June 25, 2009
Subject: **York**
Federal Project No's: BH-1511(000)X,
BH-1511(100)X, BH-1511(200)X
State Pin No's: 015110.00, 015111.00,
015112.00
Amendment No. 1

Make the following changes to the Bid Documents:

In the plans **REMOVE** the following Plan Sheet and **REPLACE** them with the attached new Plan sheets:

RETAINING WALL PLAN
(Guardrail Not Shown)
Scale: 1/8" = 1'-0"

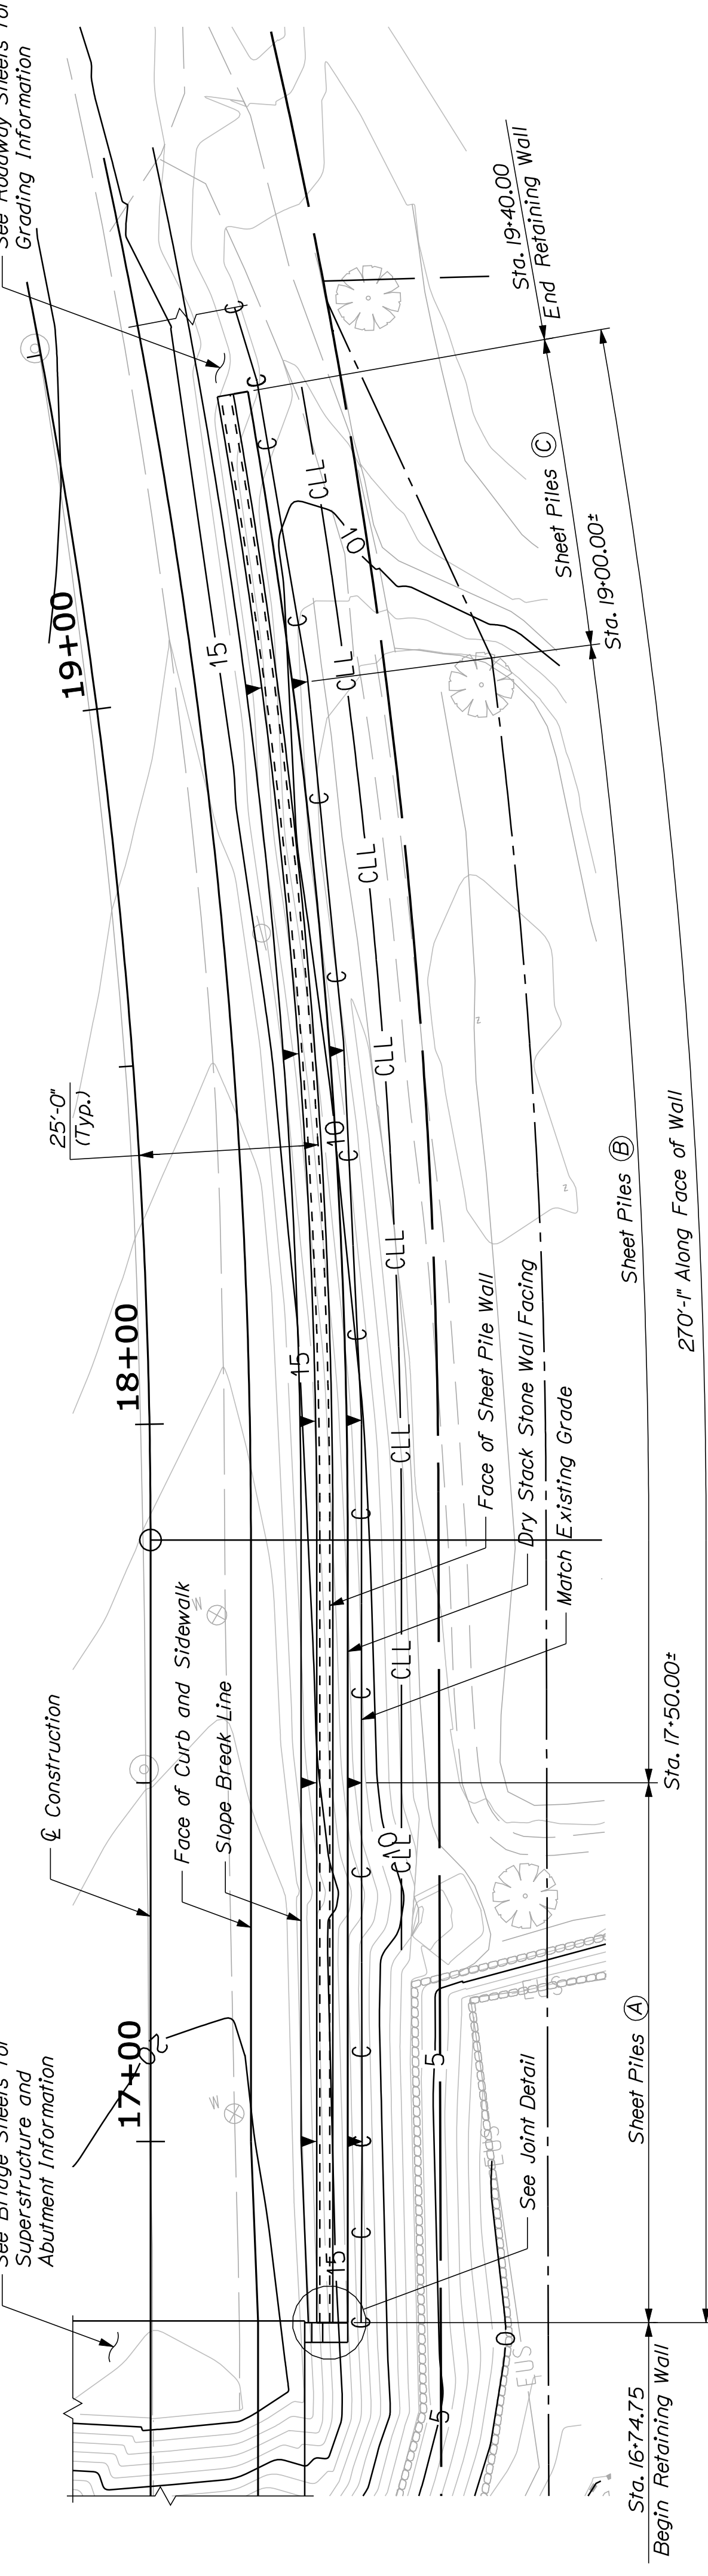
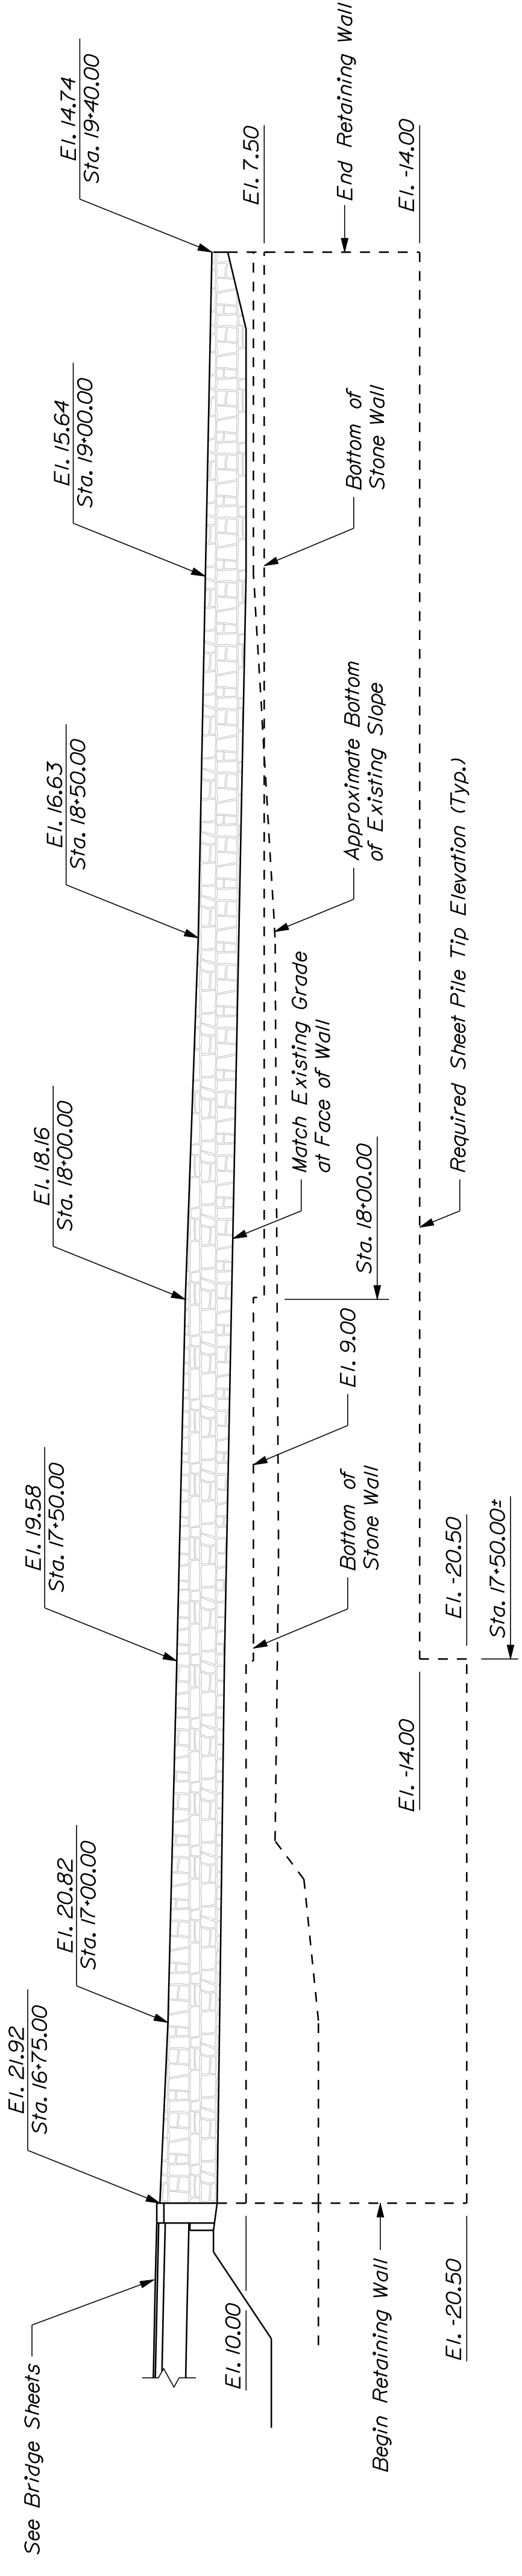
- Sheet piling material shall be ASTM A328. All cost shall be included in Item 501.301, Steel Sheet Piling.
- The Contractor shall determine the location of all existing utilities prior to sheeting installation. The proposed retaining wall may be penetrated by stopping any one or two single sheet piles over existing or proposed utility and continuing adjacent sheets.

- Place at least 18-inch wide woven geotextile or geogrid strips between the stones of the dry stack stone facing and connect firmly to the sheet piles. The strips shall be placed from center to center every 6 feet 6 inches (max) horizontally and 3 feet vertically, and shall extend from the sheet piles to three inches away from the front face of the dry stack stone wall. Contractor shall prepare and submit working drawings to the Resident for approval showing the proposed geotextile or geogrid, and the connection detail to the sheet pile wall.

- Use whole sheet pile sections in laying out sheet pile wall rather than the intermediate stationing provided to maintain a constant offset to face of wall including transition locations between A and B, and B and C.
